# UNITED STATES PATENT AND TRADEMARK OFFICE

APPLICATION NO.	FILING DATE	FIRST NAMED INVENTOR	ATTORNEY DOCKET NO.	CONFIRMATION NO.
10/052,820	11/07/2001	Manabu Tomita	09792909-5259	3195

**Office Action Summary**

**DETAILED ACTION*****Claim Rejections - 35 USC § 102***

Fig. 1A

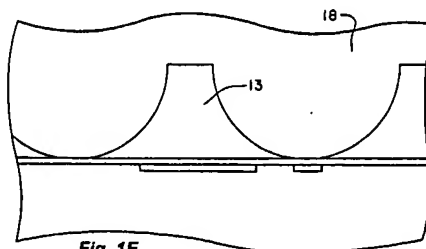
- {claim 10} A print head for ejecting ink from a nozzle (abstract; column 1, lines 11-20); a substrate on which a heating element is disposed (figure 1A, reference 10-12; column 3, line 65-column 4, line 6);

Fig. 1E

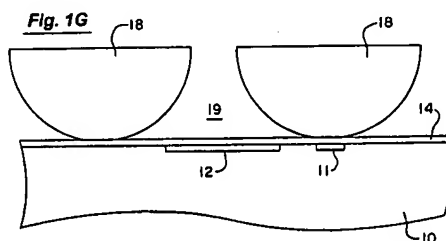
a projecting object having the same shape as hollow parts corresponding to at least an ink cell and a nozzle on the substrate, at a position above the heating element (figure 1E, reference 13); a setting resin on the substrate, the thickness of the setting resin being determined such that a tip portion of the projecting object, which corresponds to the nozzle, projects from the setting resin (figure 1E, reference 18)

- {claim 11} a cell portion of the projecting object, which corresponds to an ink cell, is covered by the setting resin (figure 1E, reference 18)
- {claim 12} the tip portion is on the cell portion (figure 1E, reference 13)
- {claim 13} the cell portion is on the heating element (figure 1E, reference 13)
- {claim 14} the projecting object comprises a photosensitive material (column 2, line 32-column 3, line 17)
- {claim 16} the setting resin forms a nozzle around the tip portion, and wherein the outlet of the nozzle is located above the heating element (figure 1G, reference 12, 18-19)
